E4418B-07A

S E R V I C E N O T E

Agilent E4418B EPM Power Meter

Premature RAM Backup Battery Failure

Figure 2. Location of Surface Mount Resistors

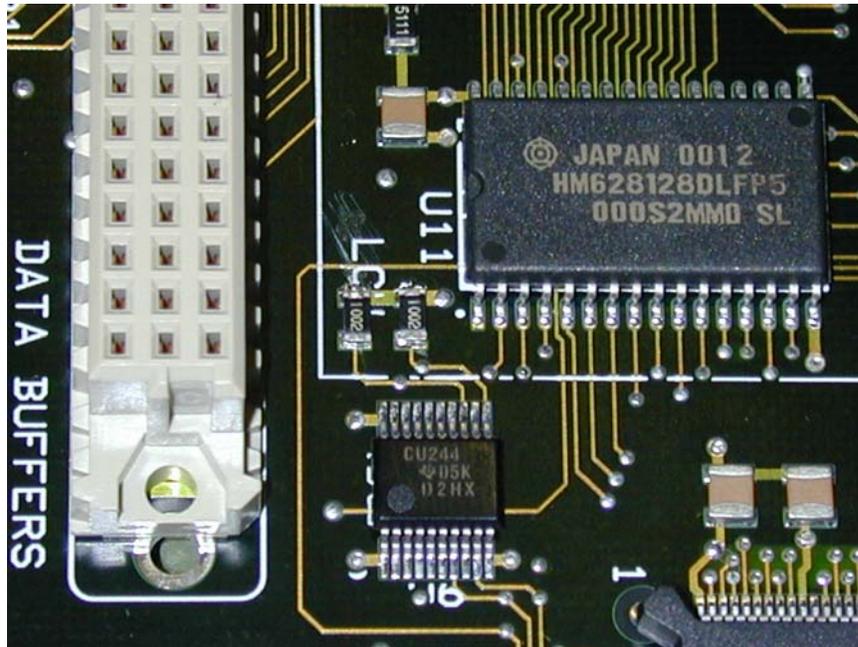
Two pull-up resistors were added as part of this design change. It has since been discovered that these pull-up resistors reduce the lifetime of the RAM lithium backup battery. The backup battery is needed to retain data in the memory when the unit is disconnected from the mains power supply. This will not affect measurement integrity of the unit, however the unit will lose all user data that was stored in it before the battery failure occurred. When the battery has failed it will display the following Power On Self Test error: RAM Battery Failed.

- Processor Assembly revisions prior to 'S' are not covered by this service note. RAM backup battery failures on these boards may be detailed in a previous service note, or they may simply be caused by natural aging of the unit. Check other service notes for this unit to verify this failure mode is not likely to be caused by any other documented problems. Do not carry out steps 4 to 14.
- Locate the two surface mount pull-up resistors (see Figure 2).

Figure 3. Surface Mount Resistors Removed from Board

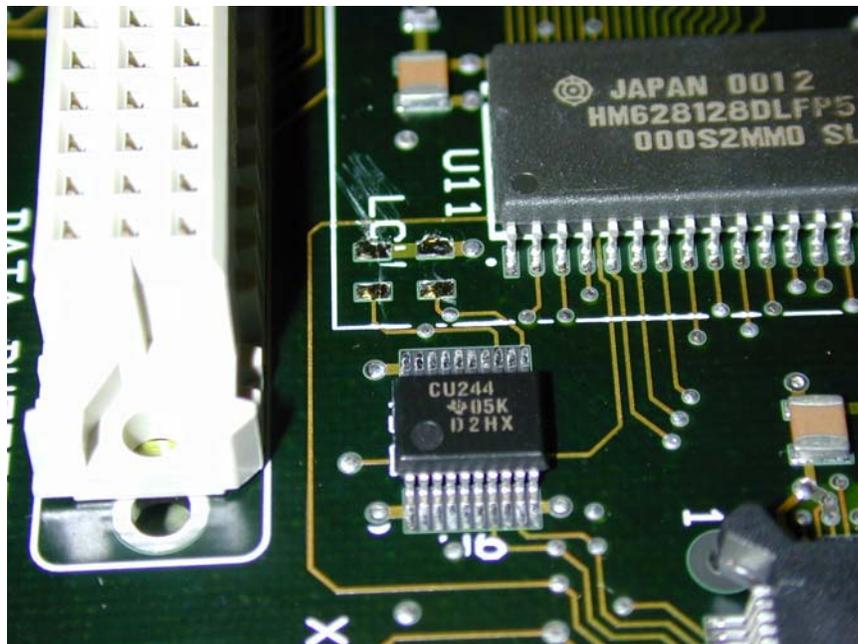
- Remove the two surface mount pull-up resistors (see Figure 3).
